PIC16(L)F72X Family Silicon Errata and Data Sheet Clarification

The PIC16(L)F72X family devices that you have received conform functionally to the current Device Data Sheet (DS41341**E**), except for the anomalies described in this document.

FIGURE 1: HFINTOSC FREQUENCY ACCURACY OVER DEVICE VDD AND TEMPERATURE⁽¹⁾

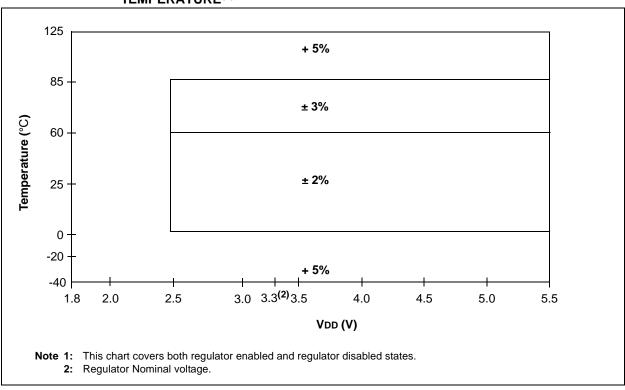
3.3 Frequency Tolerance

The frequency tolerance of the internal oscillator is $\pm 2\%$ from 0-60°C and $\pm 3\%$ from 60-85°C (see Figure 1).

None.
